**SUBJECT:** NuScale Power, LLC Supplemental Response to NRC Request for Additional Information No. 90 (eRAI No. 8758) on the NuScale Design Certification Application

Enclosure 1: NuScale Supplemental Response to NRC Request for Additional Information eRAI No. 8758

**eRAI No.:** 8758

**NRC Question No.:** 18-1

## Utilization of the Third Crew

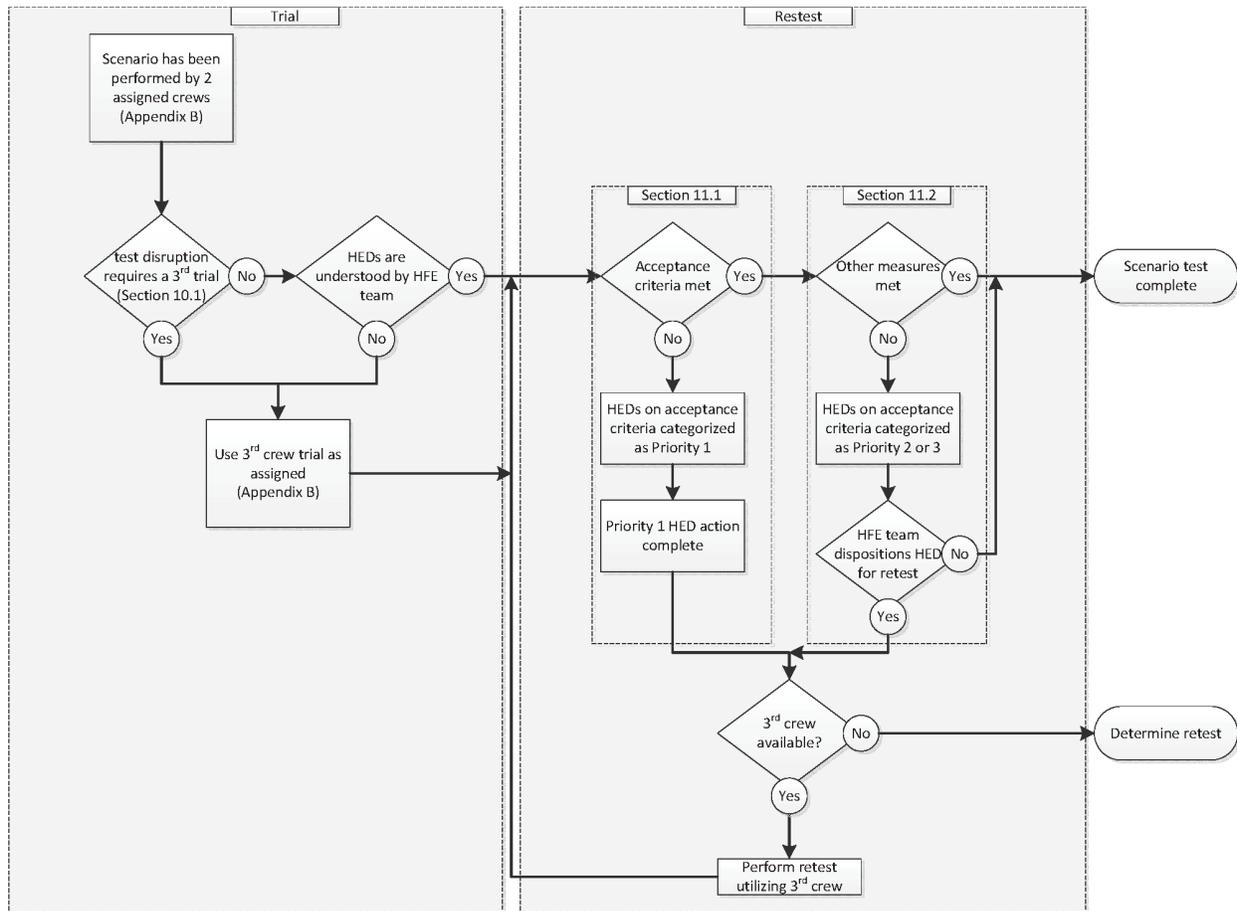
**Question 1:**

Criterion 11.4.3.8, "Validation Conclusions," in NUREG-0711, states, "the applicant should document the statistical and logical bases for determining that the performance of the integrated system is, and will be acceptable."

The NuScale Verification and Validation Implementation Plan, Section 4.6.1, "Scenario Sequencing," says a minimum of two operating crews will perform each scenario. However, the bases for determining that the performance of the integrated system will be acceptable using a minimum of two operating crews per scenario is not described in the application.

Additionally, the NRC Commission has previously taken action based on a greater number of scenario trials. The staff is concerned that a minimum of two trials for each ISV scenario does not provide (1) enough opportunities for users of the integrated system to identify errors with the design or (2) reasonable assurance that results from the ISV test will be indicative of the ability of the integrated system to support safe plant operation. Please describe the bases for determining that performance of the integrated system using a minimum of two operating crews

NuScale intends to utilize three full crews and to rotate each crew through the performance of scenarios as described in the ISV Test Plan Appendix B. The following flowchart illustrates how the use of the third trial is implemented as described in the ISV test plan. The flowchart contains the applicable sections of the ISV test plan listed in the decision or as grouped by the dashed line.

Additionally, the flow chart is separated by "trial" and "retest". A "trial" is an additional test of performance that is used to obtain further diagnostic data. A "retest" is performed after an HED resolution has been implemented to validate that the resolution is effective.

Pilot testing is not specifically discussed within the ISV test plan as it is a development activity. The number of pilot tests both prior to ISV and prior to performing a retest are based on ensuring that testing activities are ready to be performed. It is expected that any retest will undergo pilot testing to provide confidence of the HED resolution prior to formal testing. If an HED is identified that is classified as priority one, it will be tested by two crews that may have been previously tested until the resolution is satisfactory with those crew members. The formal validation test will be performed by either the third remaining crew or by developing a new scenario which tests the failed function. This formal validation is described in the ISV test plan.
